Re: St. Lucie Unit 1
Docket No. 50-335
In Service Inspection Plan
Third Ten-Year Interval
Relief Request 22

**St. Lucie Unit 1 Relief Request 22
External Weld Between Small Bore Nozzle and
Reactor Coolant Piping Hot Leg**

FIGURE 3
FLOW NOZZLE NEW EXTERNAL WELD

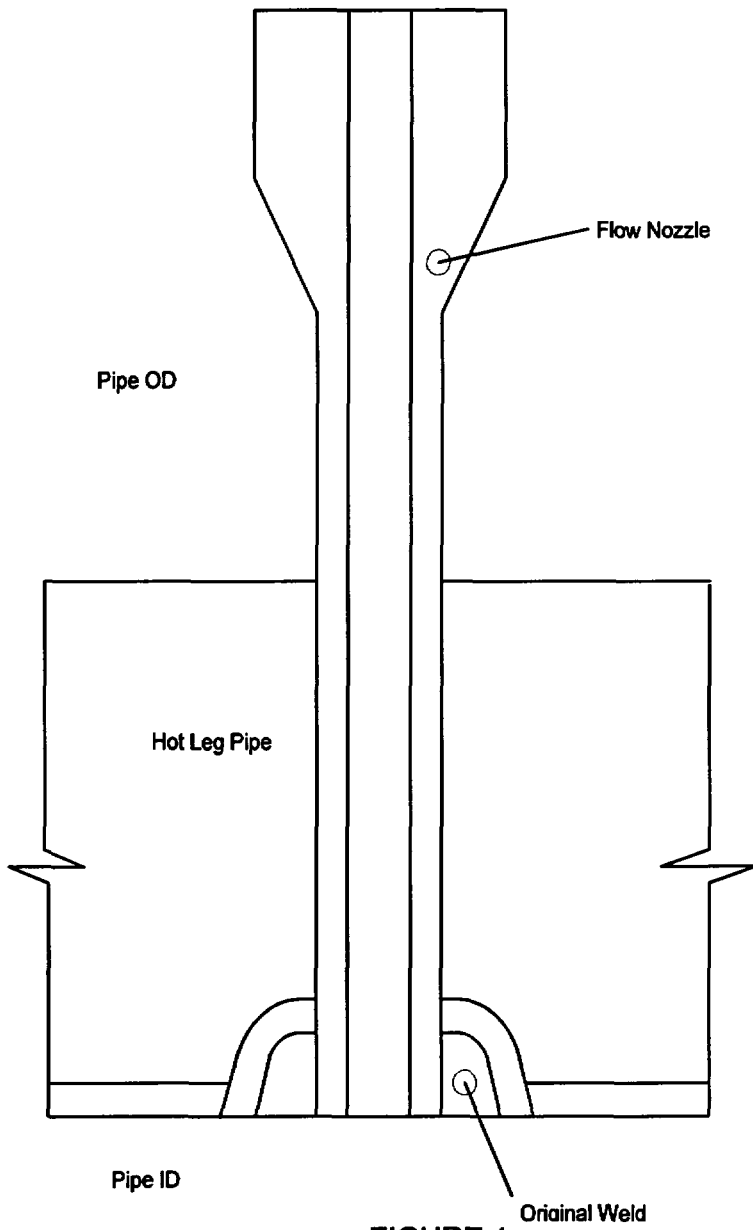
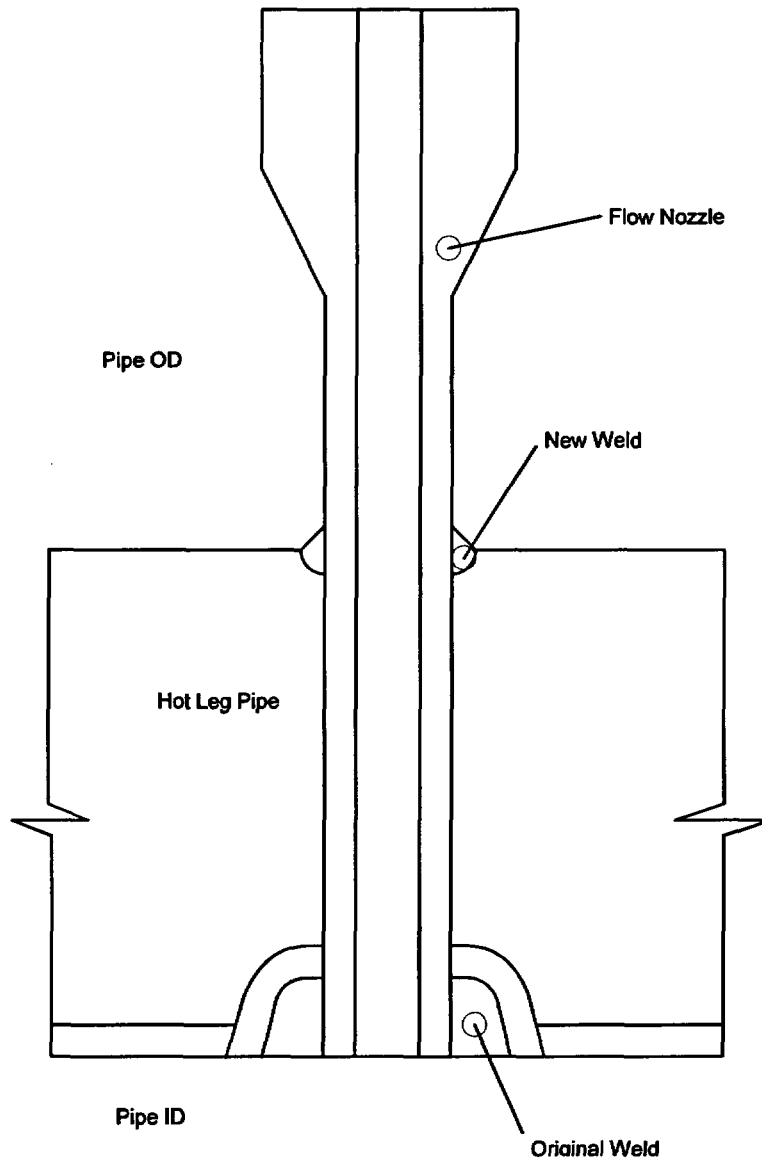
During the upcoming St. Lucie Unit 1 outage (SL1-19), FPL will be examining the RCS hot leg flow measurement and RTD nozzles for evidence of leakage. Nozzles that show evidence of leakage will be repaired. The proposed repair will be a partial penetration weld with fillet reinforcement applied to the external surface of the hot leg piping at the junction with the nozzle. The weld joint design will comply with the ASME Boiler & Pressure Vessel Code, Section III, Subsection NB, 1989 Edition, No Addenda, Figure NB-4244(d)-1, design (e), except for dimension " λ ", the gap at the internal end of the nozzle. Dimension " λ " should be 1/16 inch minimum. The repair weld will not produce a gap between the new external weld and the internal end of the nozzle; therefore " λ " will be 0 inches. The repair configuration for the flow nozzle is shown in Figure 3 and the repair configuration for the RTD nozzle is shown in Figure 4.

The repair will be a partial penetration weld with fillet reinforcement applied to the external surface of the hot leg piping at the junction with the nozzle. The welding will be done manually using the GTAW process, F-43 filler metal, preheat of 200 degrees F and no post weld heat treatment. The welding procedure specification has been qualified in accordance with ASME Boiler & Pressure Vessel Code, Section IX.

As defined by Reference 2, NB-3352.4(d), "λ" is to be 1/16 inch minimum. The proposed repair will not establish such a gap and "λ" will be zero. The new weld configuration, a nozzle penetrating a pipe with attachment welds at both the inside and outside diameters of the pipe, will require analysis in accordance with Reference 2. An appropriate analysis has been performed, References 3 and 4,

The calculations (References 3 and 4) have shown that the proposed partial penetration weld joint design without an axial gap and with an increased weld size is an acceptable alternative to the weld joint design described in ASME B&PV Code, Section III, Figure NB-4244(d)-1, sketch (e).
